West of Orkney Windfarm Offshore EIA Report Addendum

Marine Archaeology and Cultural Heritage Additional Information

ASSIGNMENT L100632-S15
DOCUMENT L-100632-S15-A-REPT-006

Document Number	WO1-WOW-PER-ENV-RPT-0010
Revision	01
Approved	
Mr Stuart McAuley - Offshore Wind Power Limited	
Oct 9, 2024, 9:42 PM GMT+1:00

East view

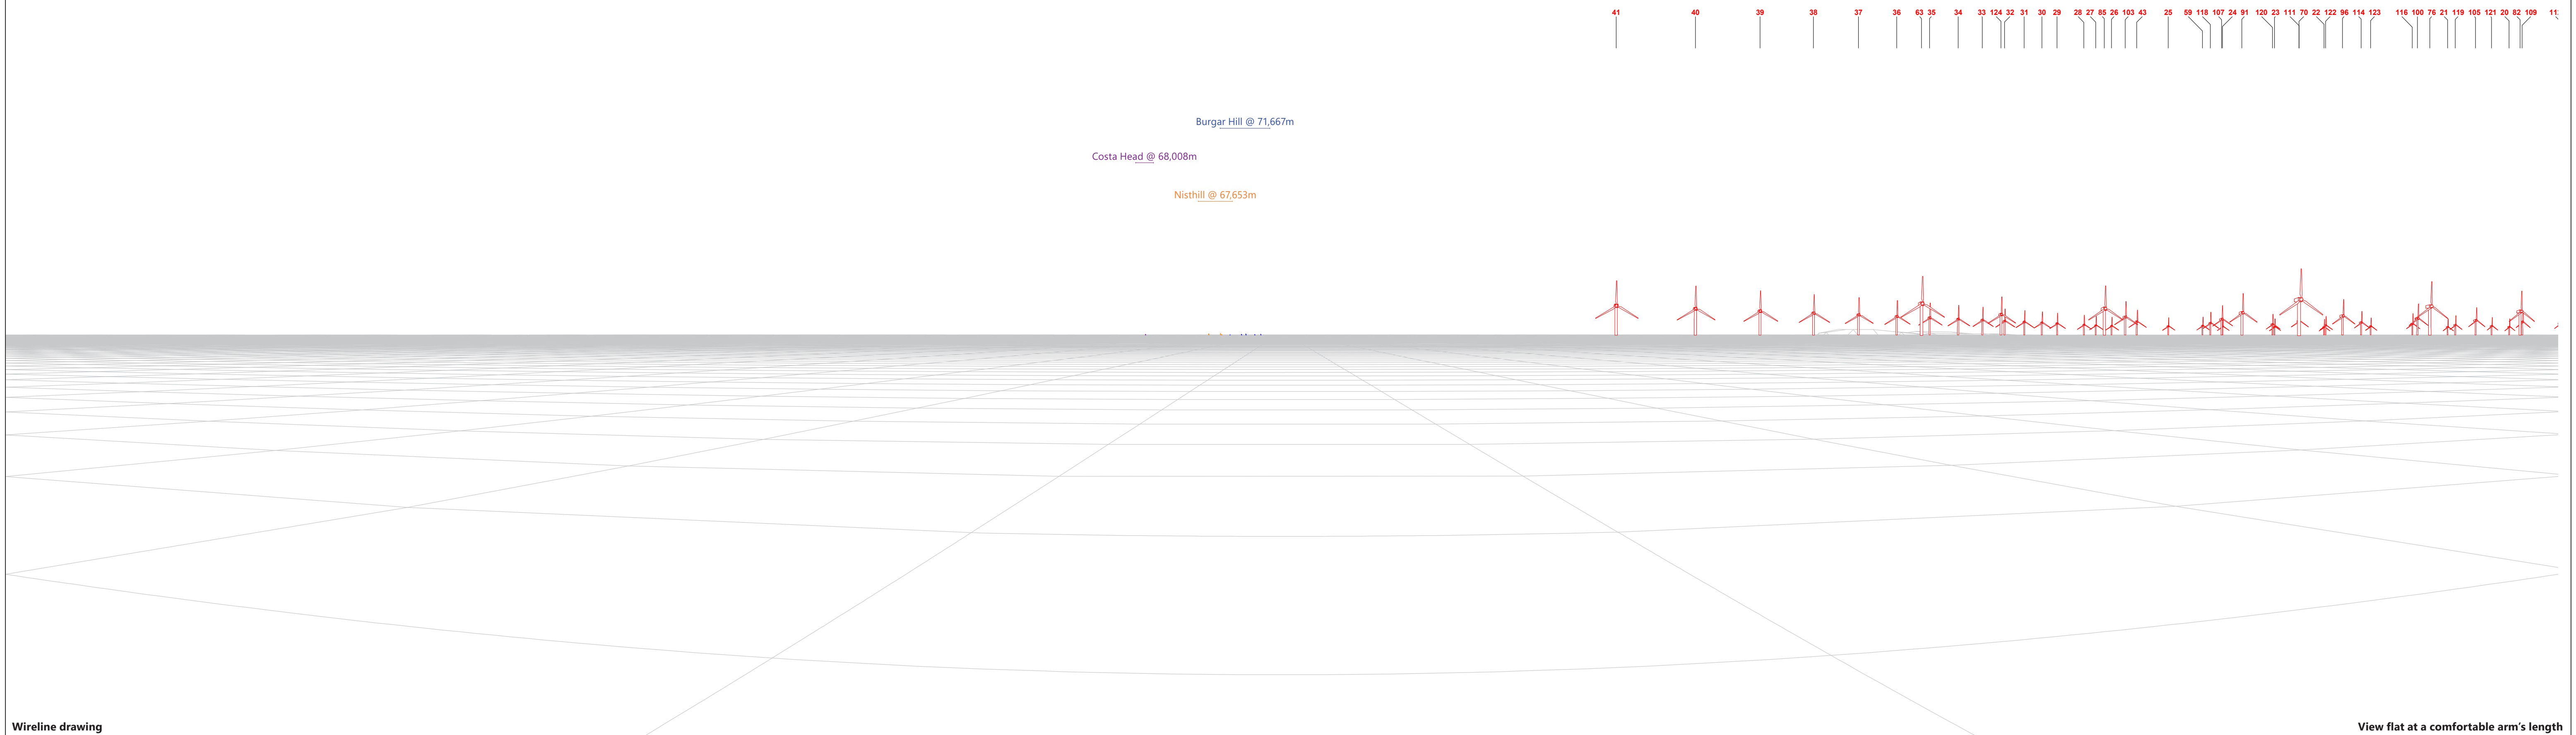
The wirelines (Appendix A) illustrate that the OAA will be visible in views to the south and east of the lighthouse at the closest distance of around 9 km. It will appear as a line of WTGs on the near horizon, albeit with some gaps between them, and will appear as a modern element in views from and to the lighthouse. The OAA will occupy a small percentage of the sea view around the lighthouse and will not detract from its open and panoramic quality. Despite the proximity of the OAA, the lighthouse will not appear to be surrounded by, or be competing in scale with, the OAA and the key intervisibility with Sule Stack will not be affected.

Views south, southeast and east towards Orkney (in particular in the direction of Stromness) and the north coast of mainland Scotland, as well as sightlines between other lighthouses (particularly at night) may be interrupted in places, but they will not be obscured.

Although the lighthouse is considered to have a high sensitivity to change on its defined setting, it is considered that none of the key elements of its setting (as set out in section 4.1.3.2) will be significantly altered. The impact on the setting of the Sule Skerry Lighthouse will be of Low magnitude and will therefore have a Minor effect and is therefore not significant for the purposes of this assessment.
